ADDENDUM NUMBER ONE

DATE: March 28, 2019

PROJECT: City of Myrtle
Renovations to 13th Ave. South for Facilities Maintenance

SECTION 1
SCALE: 3/4" = 1'-0" S2.0

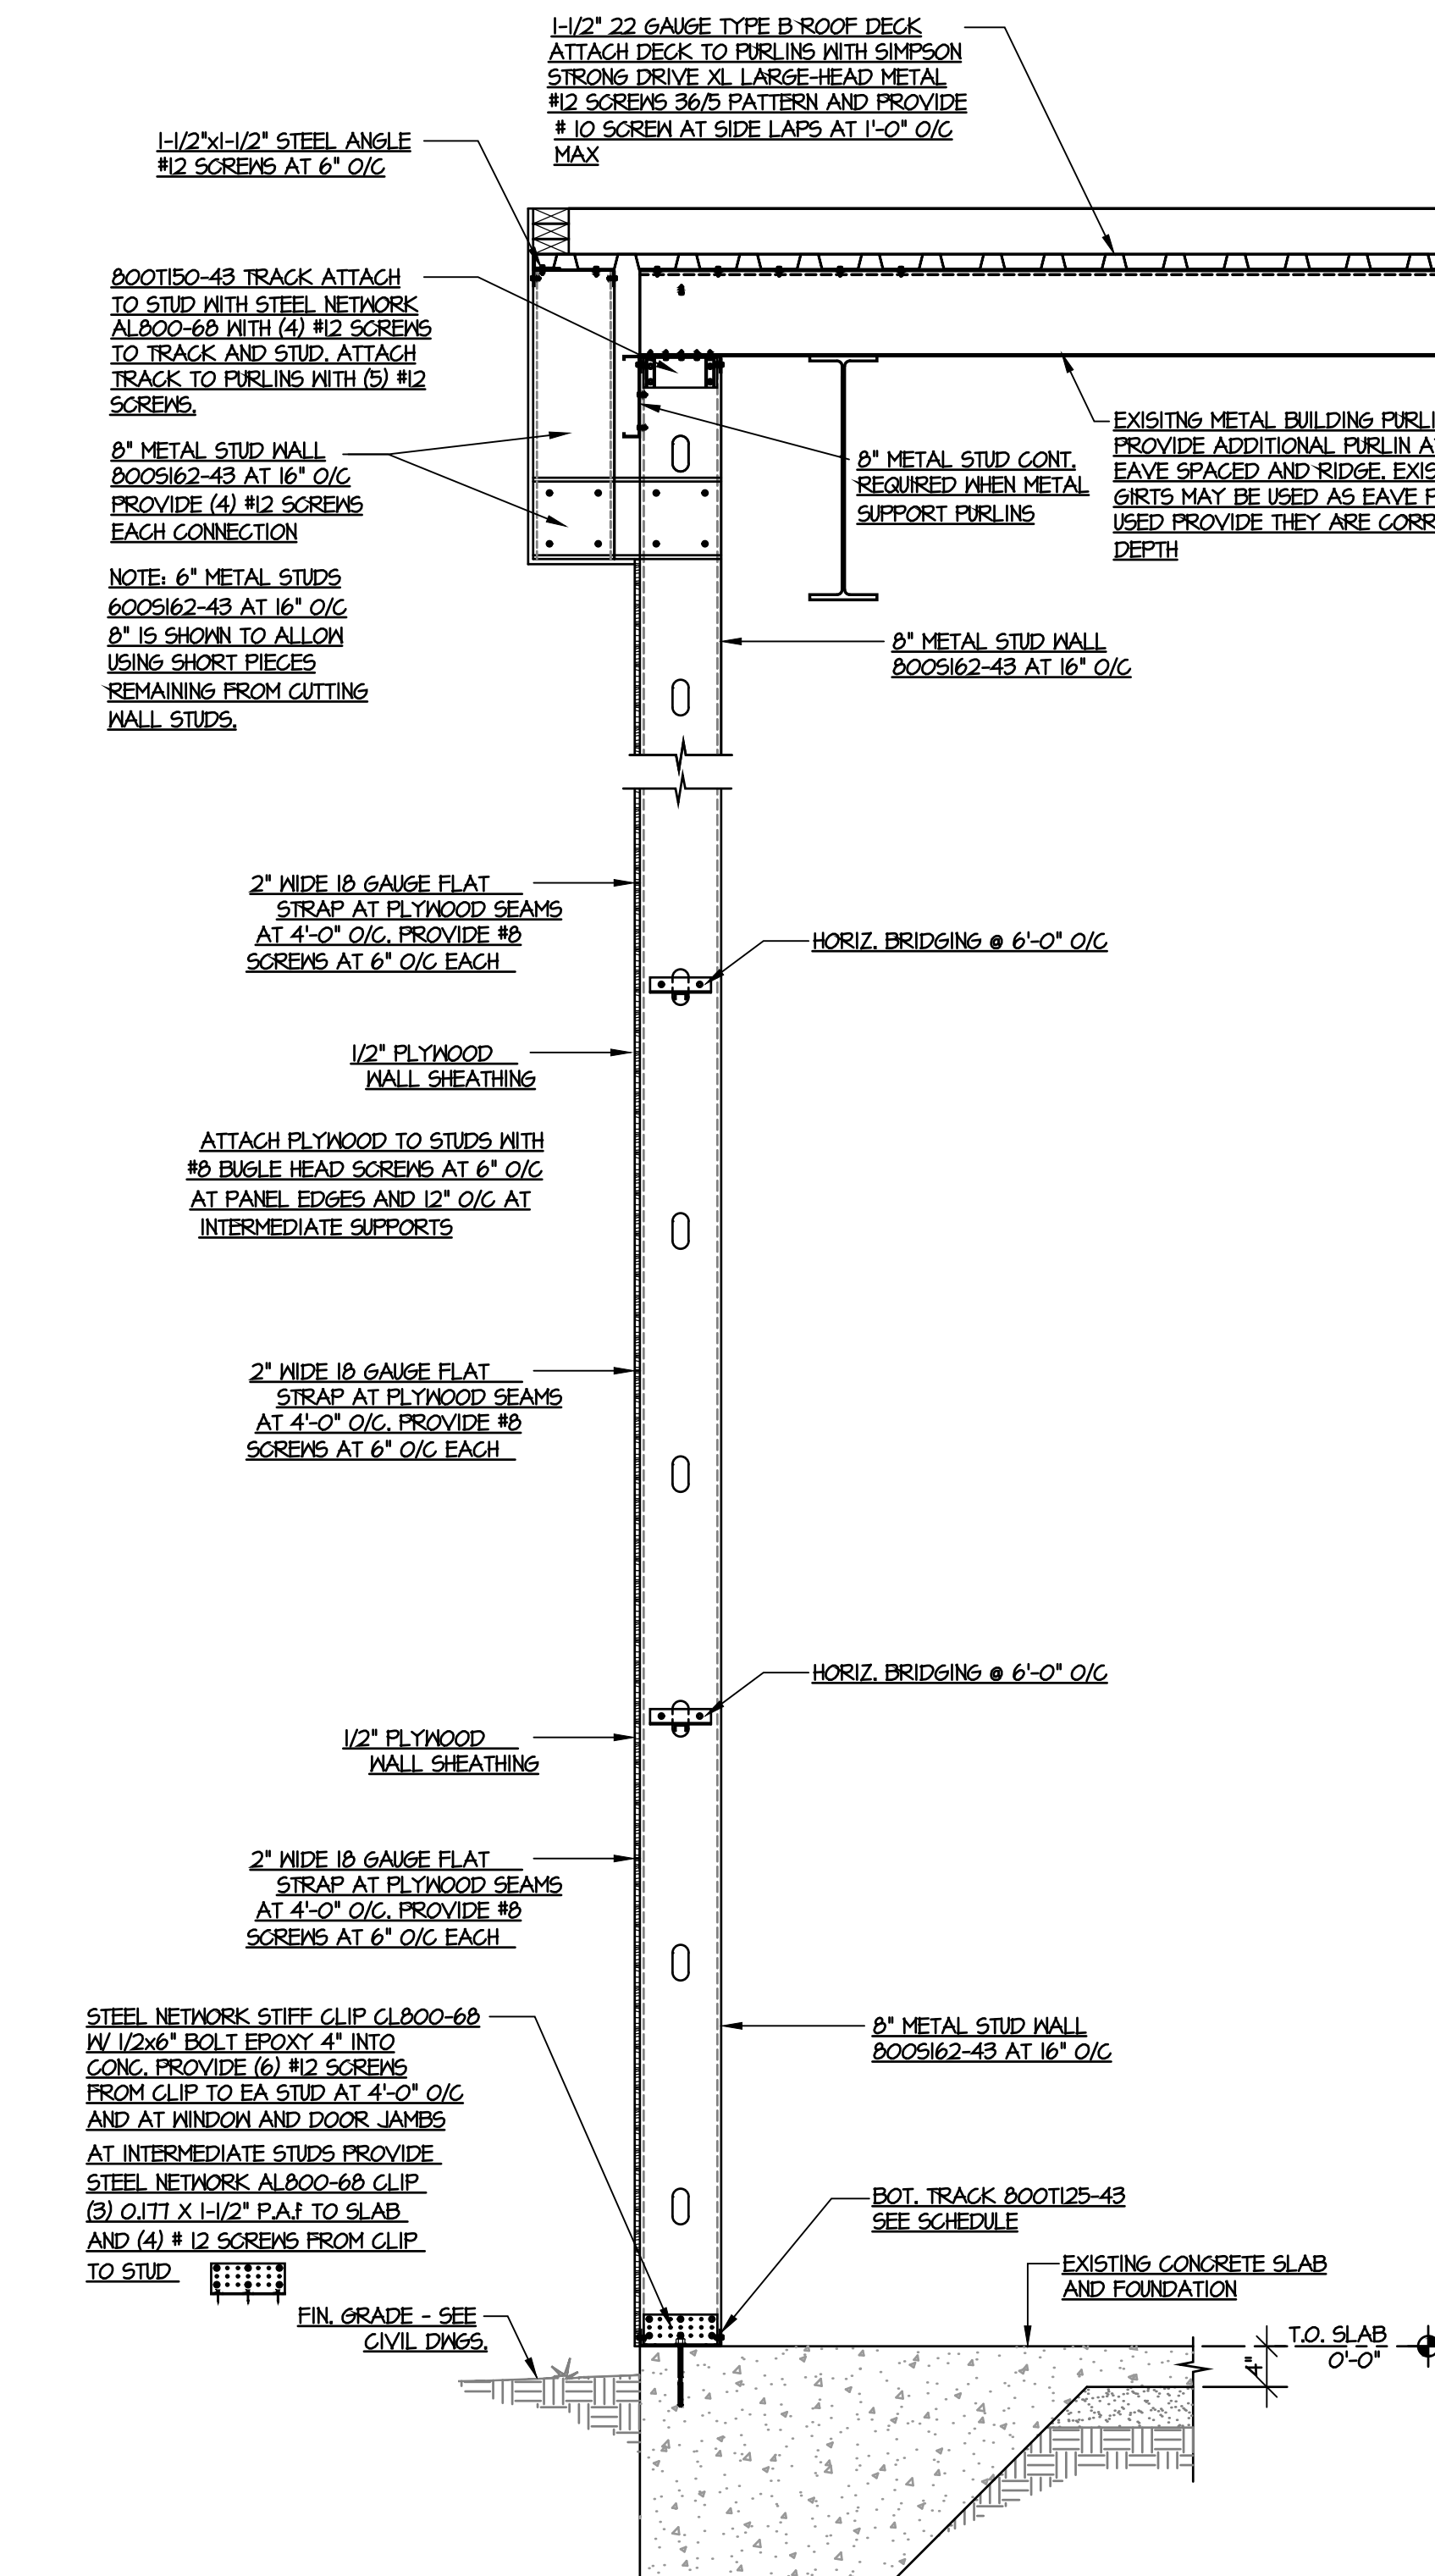
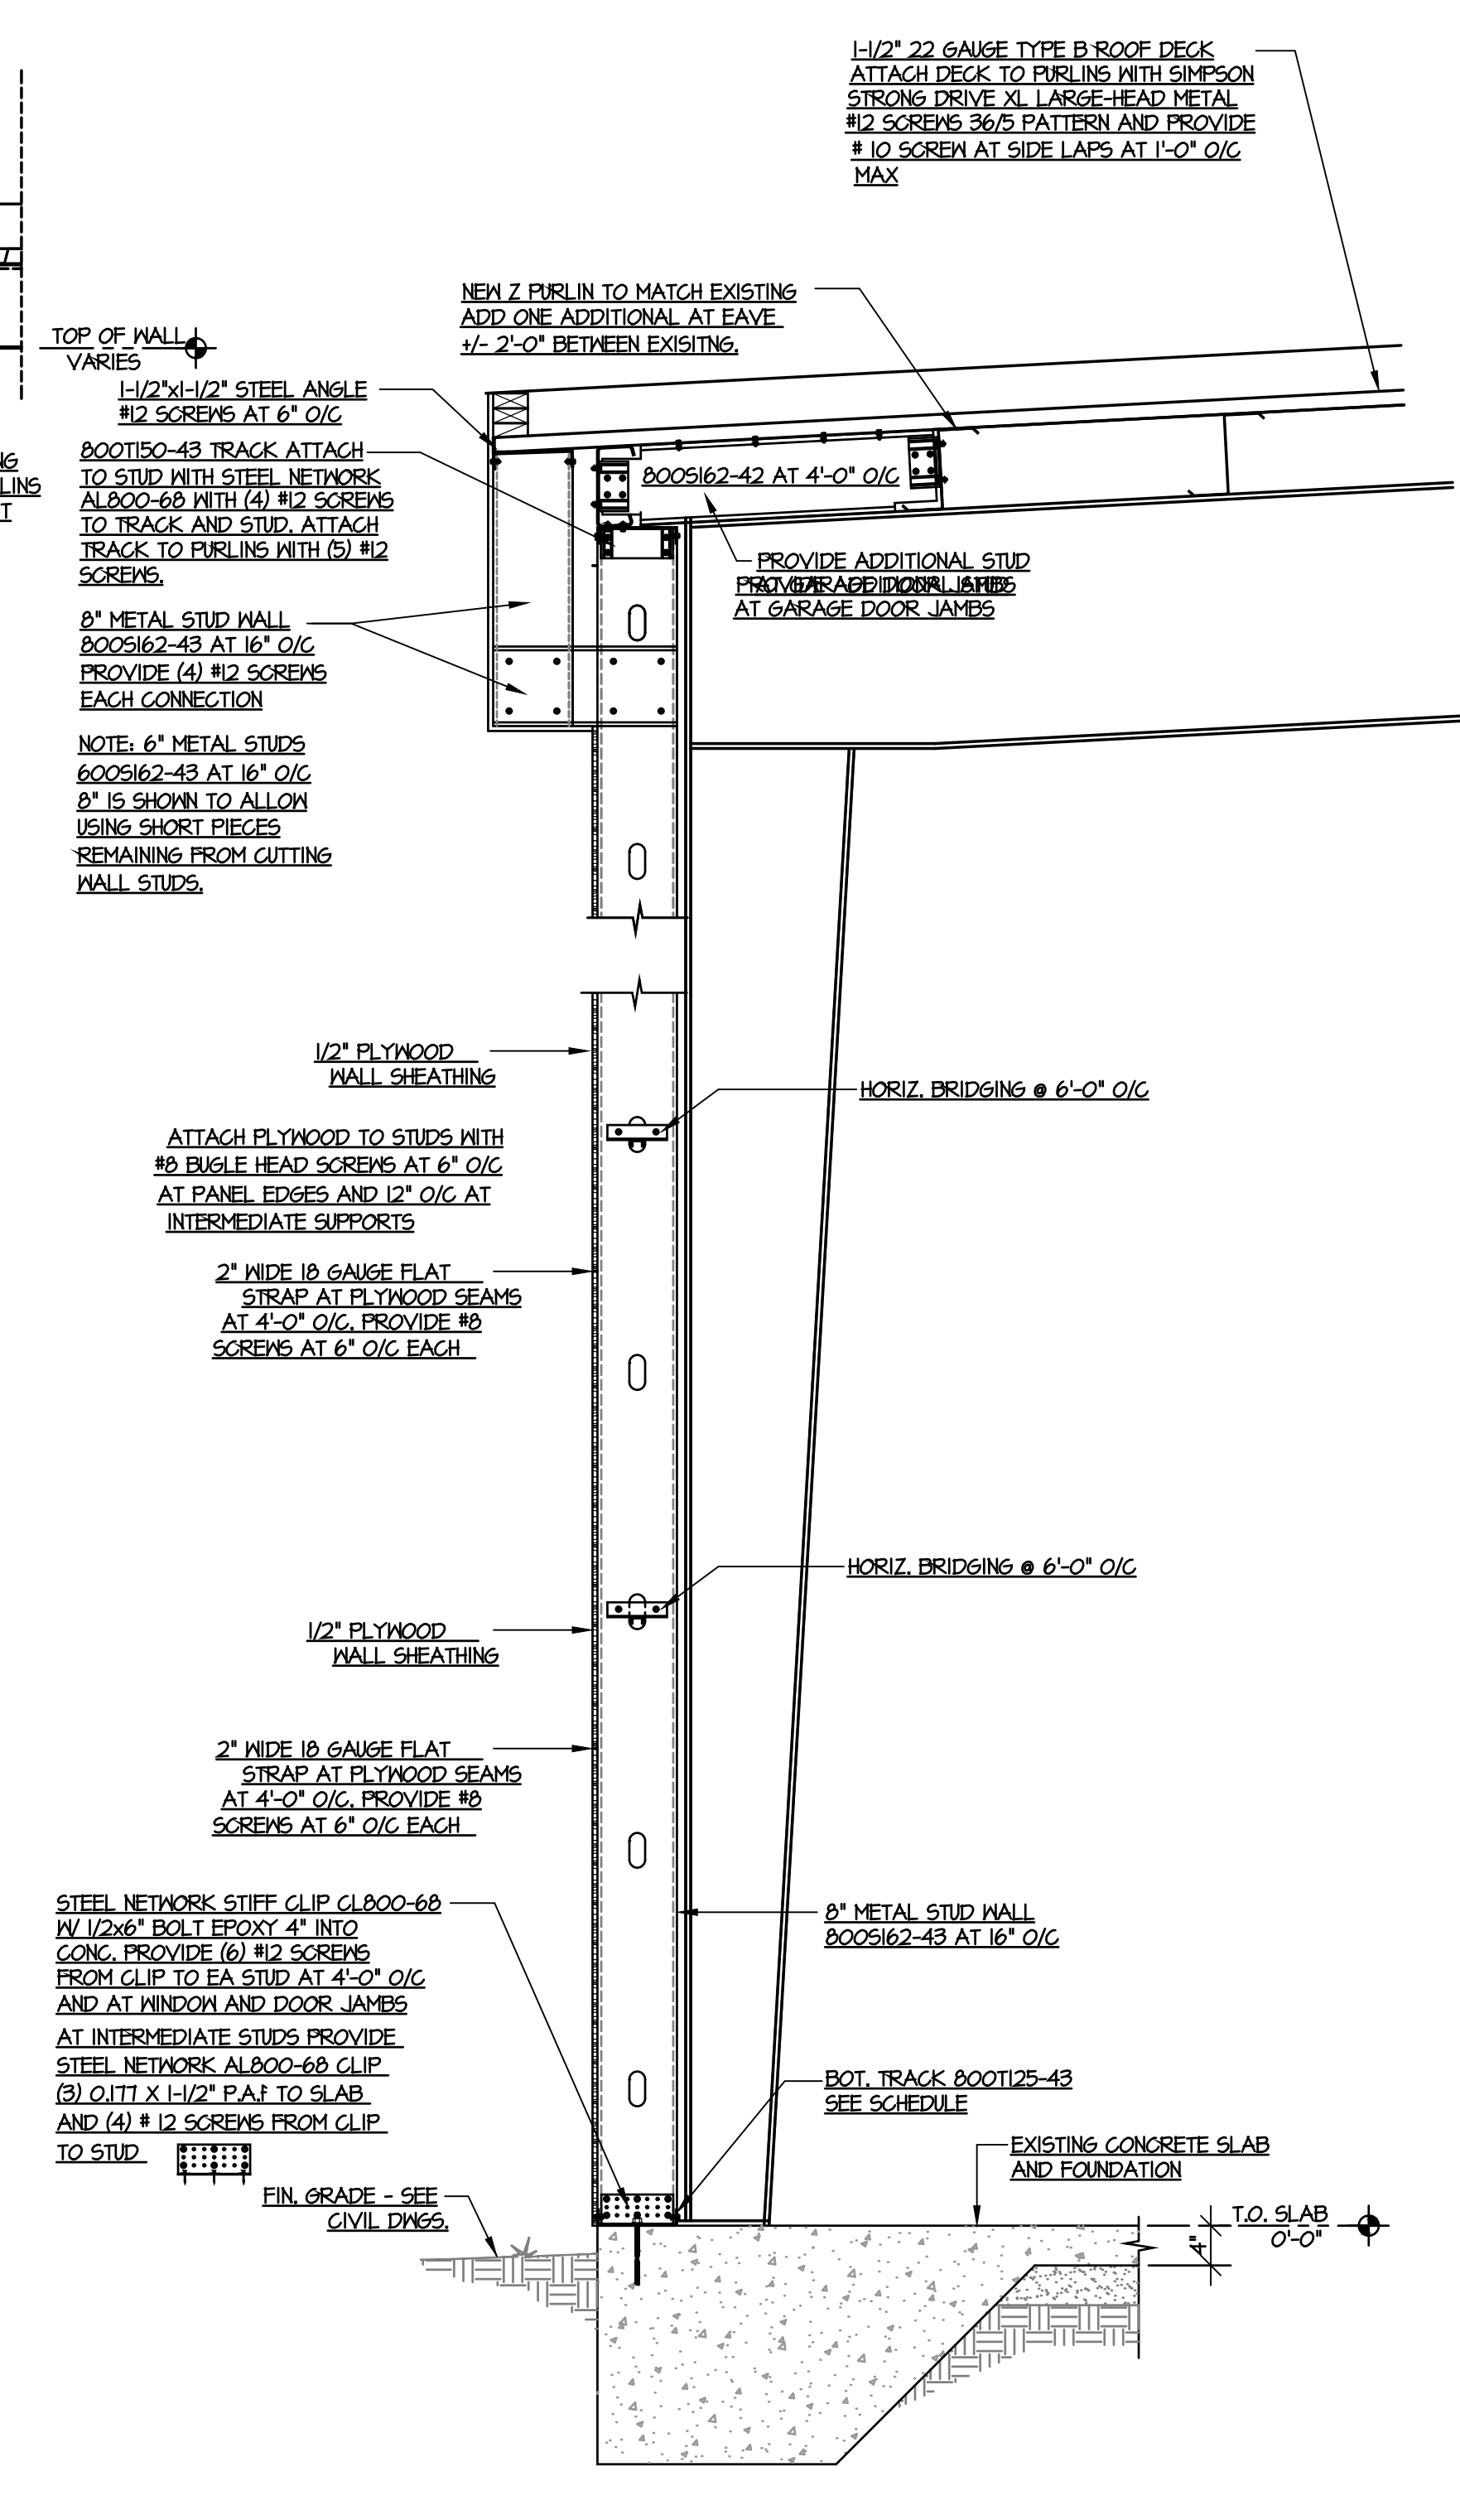
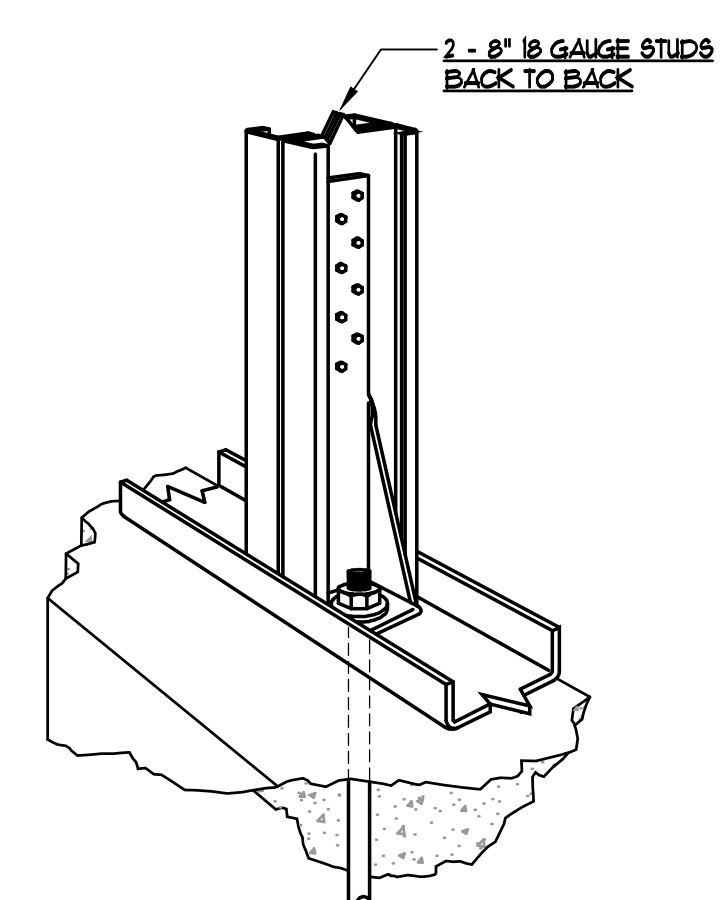
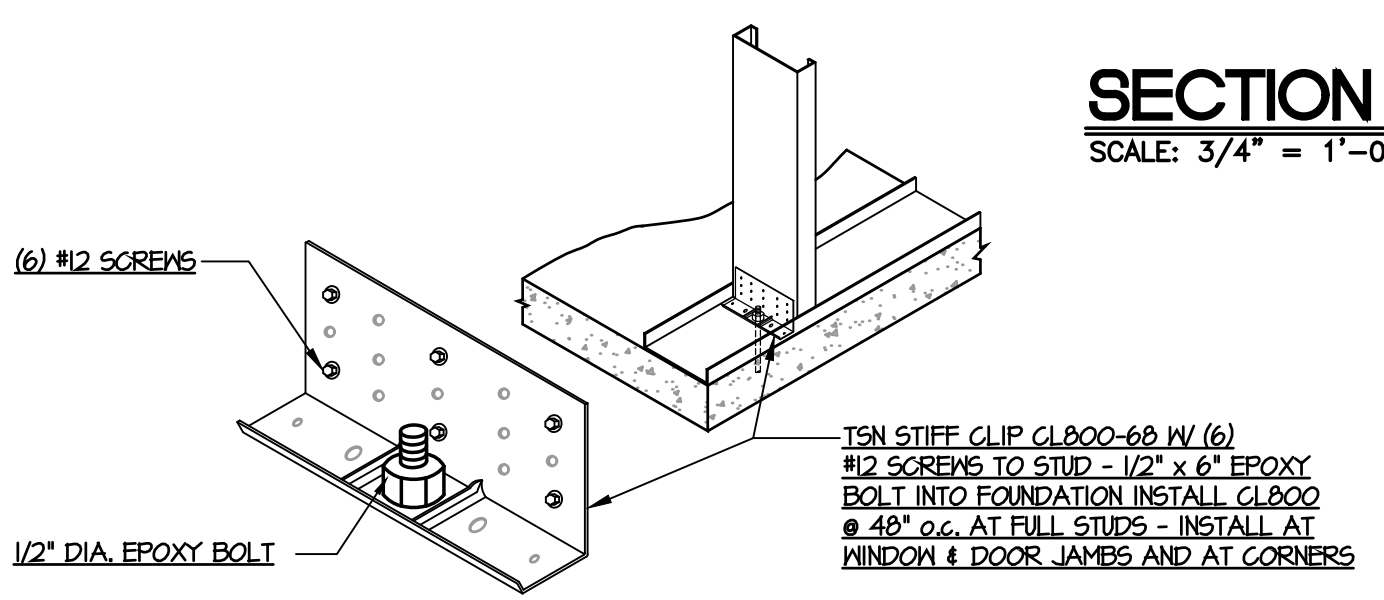
Refer to modification of the porch framing from wood to metal studs and metal decking.
